Meeting Date: February 15, 2022

AGENDA MEMORANDUM

Title: Resolution Approving a Variance Pursuant to Section 2.3.1.1 of the Transportation Design Criteria Manual for the Omission of a Sidewalk on Proposed Timbermill Parkway in the Meadows Development [*Located in Section 28, Township 7 South, Range 67 West, Town of Castle Rock*]

Figure 2: Proposed Street Location and Sidewalks

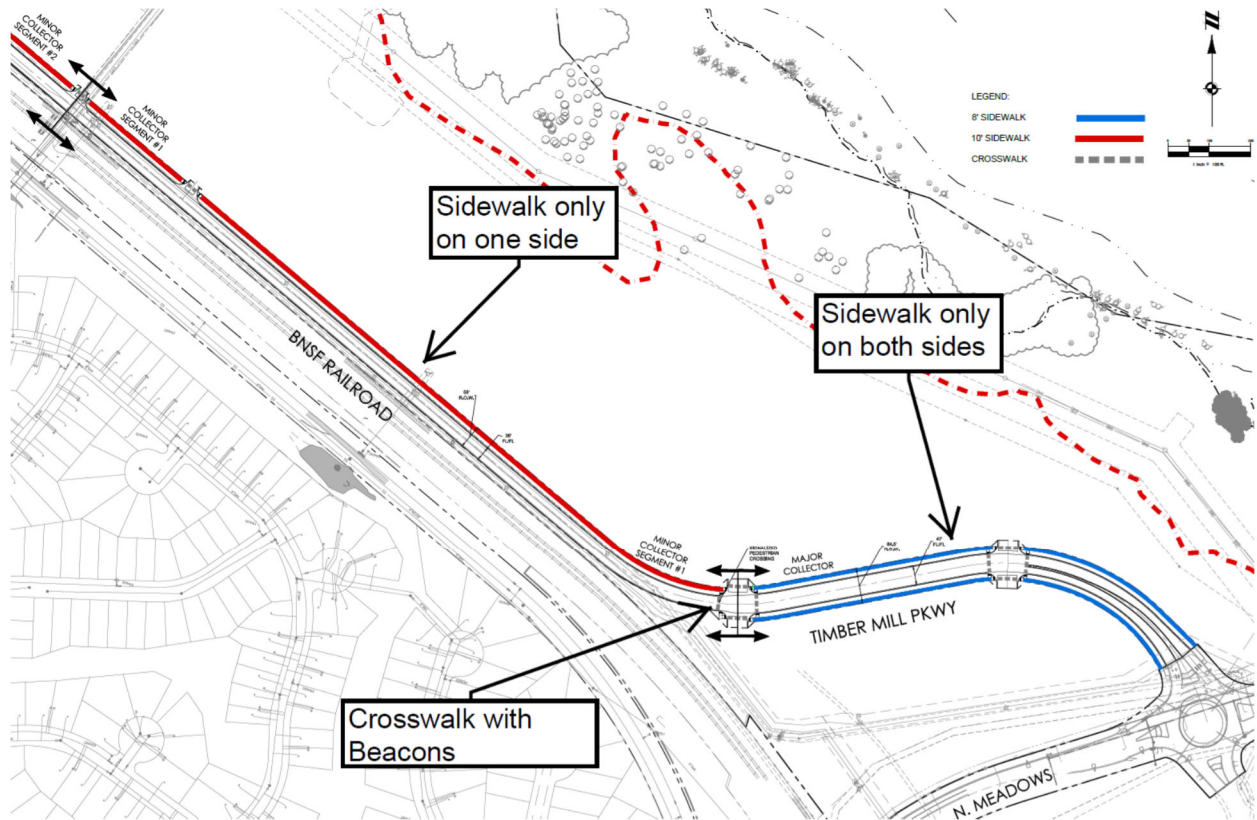
The applicant has submitted a Technical Criteria Variance (TCV) application that includes the justification for omitting one of the sidewalks on a portion of the proposed street. The TCV is attached as Exhibit 1. In addition, a plan showing the street location and proposed sidewalks is included as Figure 2 in this report. The provided justifications to omit the sidewalk include:

- There is no planned development on the side of street where the sidewalk is omitted.
- A sidewalk immediately adjacent to a railroad poses a safety concern.
- A sidewalk that does not connect to anything, will create long-term maintenance obligations for the Town, including repair and replacement.

- The applicant will construct a wider sidewalk on the northerly side of the street where only one sidewalk is available. The proposed sidewalk width in this area will be 10 feet wide rather than the standard 8 feet wide.
- To increase crosswalk safety, the applicant will also agree to pay the Town for Pedestrian Crossing Beacons where the street transitions from two sidewalks to one sidewalk.

Staff has reviewed the justifications and proposed mitigations provided for this variance request and concurs with the applicant that the omission of the sidewalk should not have an adverse impact on public health, safety and welfare. Considering there will be no development on the street frontage where the sidewalk is omitted and the wider sidewalk on the northerly side of the street should accommodate all pedestrian traffic, the sidewalk on the railroad side of the street seems unnecessary and would be a maintenance burden to the Town.
